Re: DA0830/2020 Residential – Construction of a dwelling : 14 St Georges Square East Launceston.

Re DA00830/2020 – Construction of Dwelling at 14 St Georges Square, Launceston

Re DA00830/2020 – Construction of Dwellings 14 St Georges Square

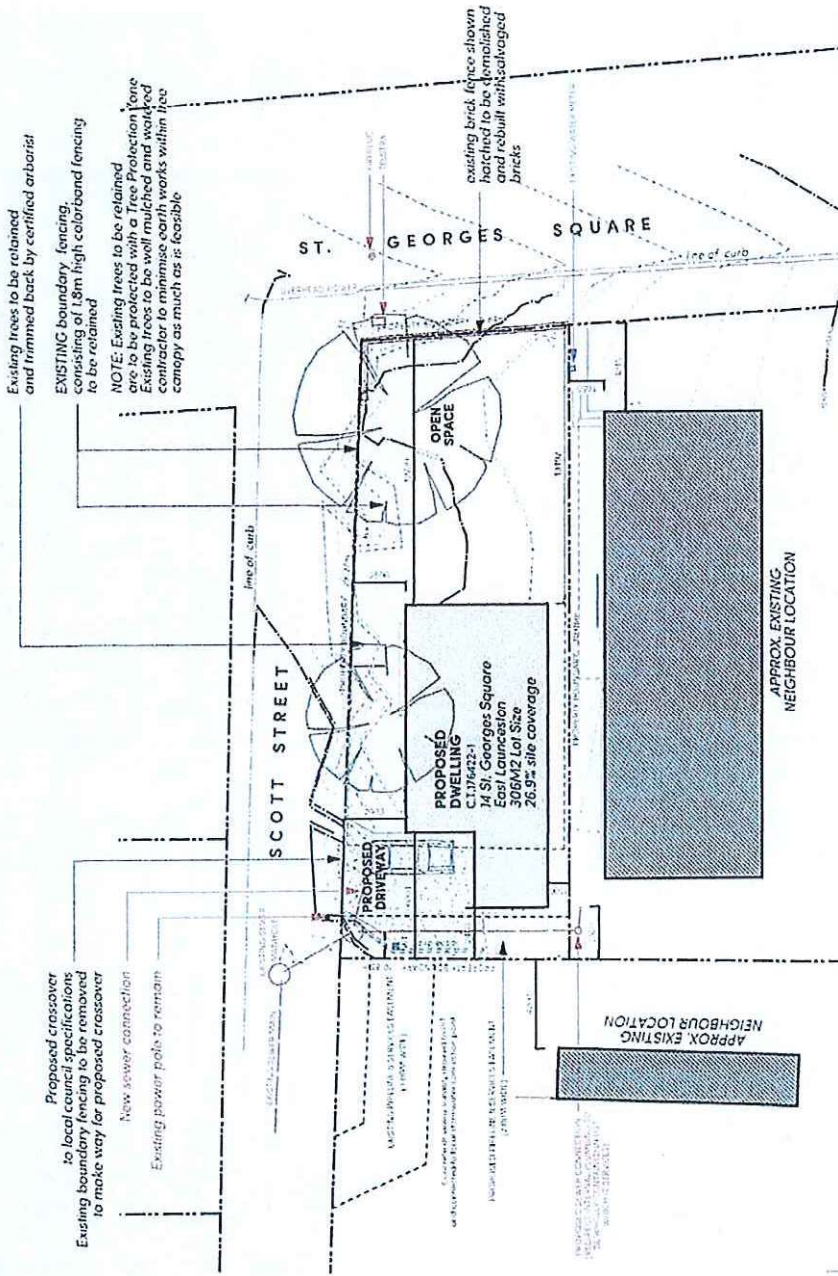
- The Vegetation Management Plan subsequently produced, expanded and further detailed, as one would expect, these requirements to the extent that the plan contains a schedule (Appendix 2) identifying specific trees to be protected, five of which are on the 14 St Georges Square block. It also goes into considerable detail outlining options as to how these trees can be protected, both before work starts and during any site works subsequently.

- The plan also goes into extensive detail as to how any excavation work should be undertaken in the tree protection zones and it details the specific processes which should be followed to put any new fence footings and do any subsequent building under the existing Chestnut Tree on 14 St Georges Square and three Catalpa trees on 16 St Georges Square.

1. Page 2 of Planning Application DA0830/2020 – New Dwelling 14 St Georges Square
2. Page 15 of Vegetation Management Plan 14 -16 St Georges Square East Launceston (February 2020)

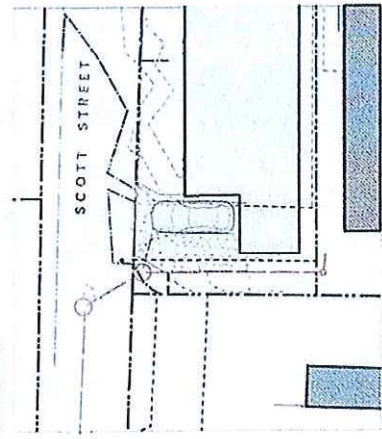
The fleeting reference to the front fence on page A1-001 (copy attached as Appendix 1) states that an existing front fence (which doesn't currently exist) will be demolished and rebuilt with salvaged bricks.

On page A1-001 of the application (copy attached as Appendix 1) it states that ***“existing trees will be retained and trimmed back by certified arborist” and “are to be protected with a Tree Protection Zone. Existing trees to be well mulched and watered contractor to minimize earth works within tree canopy as much as feasible”***

- The site plan (A-001) submitted as part of the building application is incorrect in that it gives the impression that a substantial tree exists just over half way down Scott Street. No such tree currently exists as it was removed by the applicant prior to the sub-division application decision being made by Council (June 2018). Its inclusion gives the false impression that such vegetation exists on the block and will be retained. That is just not the case.
- The site plan (A-001) also as mentioned earlier in item 2, refers to a non-existent front fence which it says it is proposing to demolish and rebuild with salvaged bricks.
